Subject: Air Conditioner Water Drain Fixing  
Bracket Installation

Bulletin Type: FC

Bulletin No: TS45-FC-2522

Vehicle Model: TS45

Figure 1

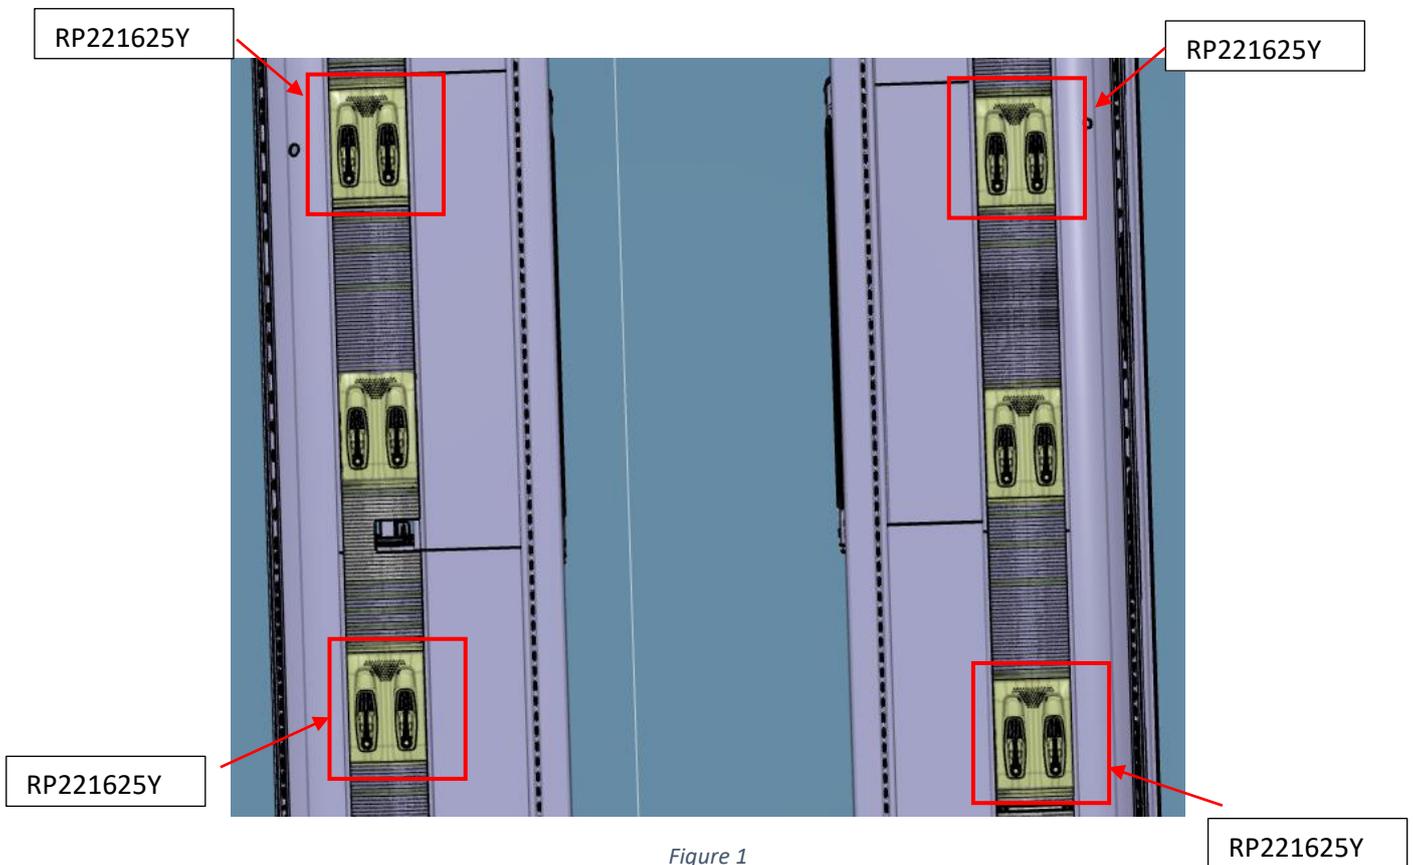
From the **RP221092Y**, the multisets numbered **RP221625Y** will be disassembled in the provided sequence and place below. These multisets are the ones near evaporators of the A/C system.

Multisets to be disassembled

- Left Side: 3<sup>rd</sup>, 5<sup>th</sup>, 10<sup>th</sup> and 12<sup>th</sup> when counted from the entrance of the vehicle.
- Right Side: 3<sup>rd</sup>, 5<sup>th</sup>, 10<sup>th</sup> and 12<sup>th</sup> when counted from the entrance of the vehicle.

Figure 2

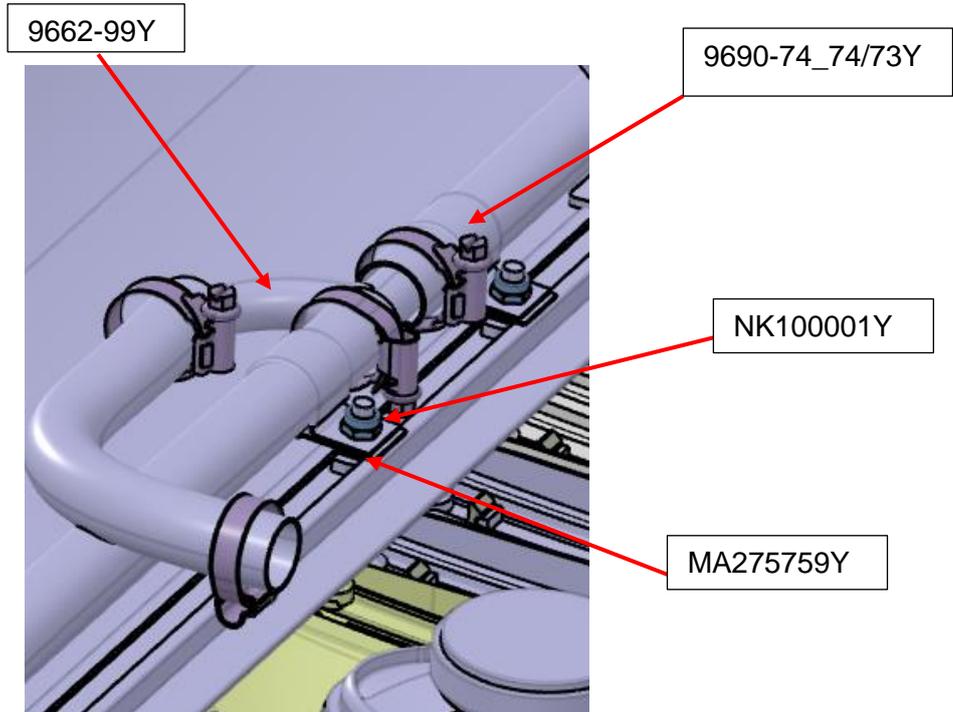
The nut, part number: NK100001Y, on clip numbered MA275759Y will be disassembled at the junctions defined below.

- Left side: Where the drain hose part no: **9690-74\_74Y** and the H-adaptor part no: **9662-99Y** meet.
- Right side: Where the drain hose part no: **9690-74\_73Y** and the H-adaptor part no: **9662-99Y** meet.

It should be noted that, for some locations, at the junction specified, there are two clips, part no: **MA275759Y**; the nut on the one indicated in below image should be disassembled.

Figure 3

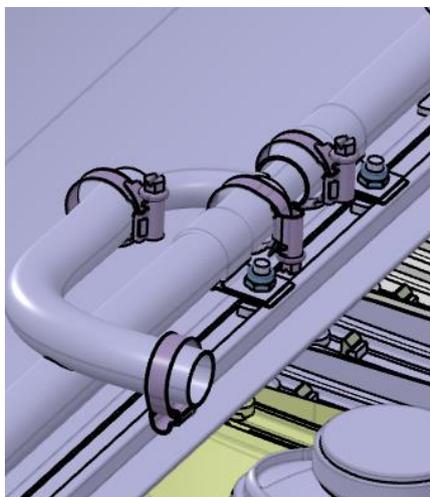
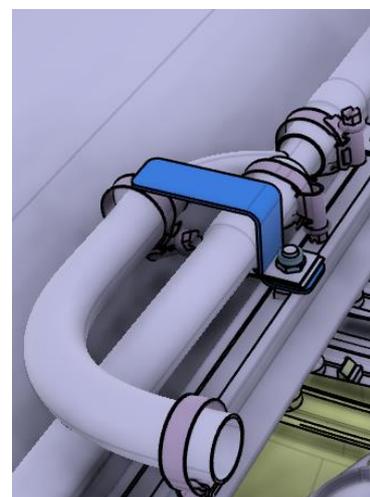
When the nut numbered **NK100001Y** on **MA275759Y** is removed, the bracket numbered **9326-10950Y** will be installed onto, the clips with bolt numbered **5356-LGE-05-06Y** and the corresponding nut numbered **NK100001Y**. Ensure that the installation is performed with the **9662-99Y** positioned parallel to the horizontal plane, with **9326-10950Y**'s longer section oriented on top.

Example installation position and orientation are illustrated in the image below and installation steps are given. Additionally, a real application image is provided as well.

CURRENT VERSION

NEW VERSION

Figure 4 Bracket Installation step.1

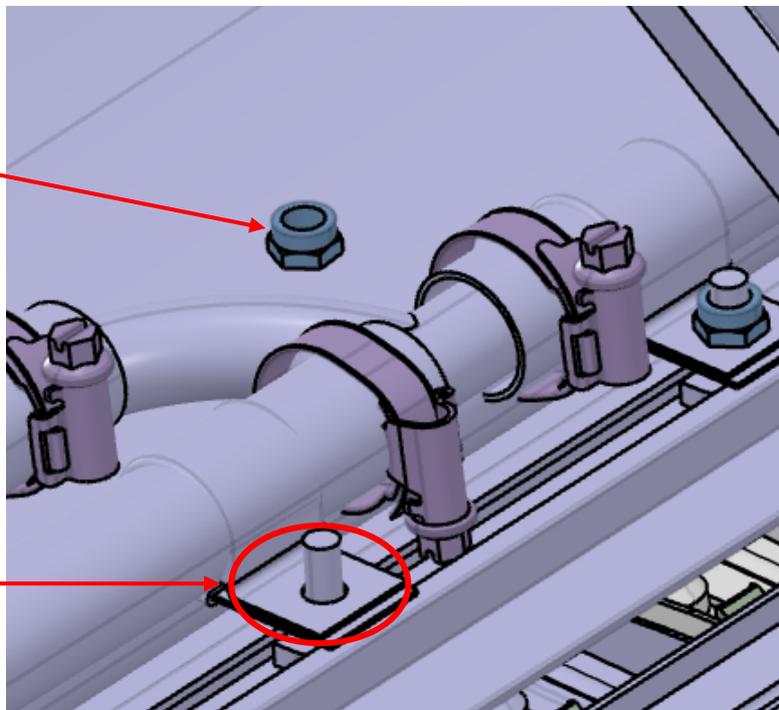
Remove the bolt  
NK100001Y from the  
clip MA275759Y

Where the bracket  
9326-10950Y will be  
placed

Figure 5 Bracket Installation step.2

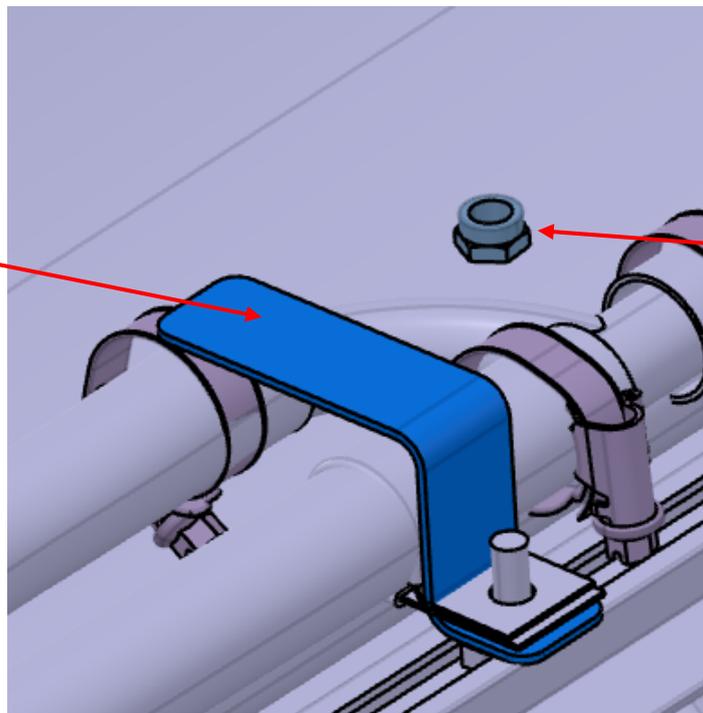
Place the new bracket 9326-10950Y in its place, on top of the clip MA275759Y

NK100001Y

Figure 6 Bracket Installation step.3

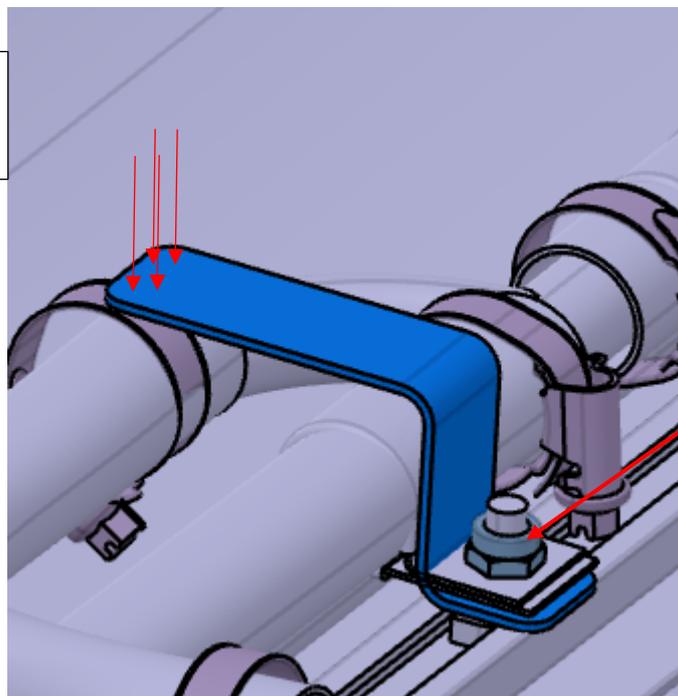
Make sure the bracket 9326-10950Y pushes down on the H-adaptor 9662-99Y

Use the same nut NK100001Y to fix the bracket 9326-10950Y to its place

**ATTENTION:** When the assembling process is ongoing, make sure that there are no electrical cables under the bracket, and the bracket pushes down to the specified location in the above figure 6.
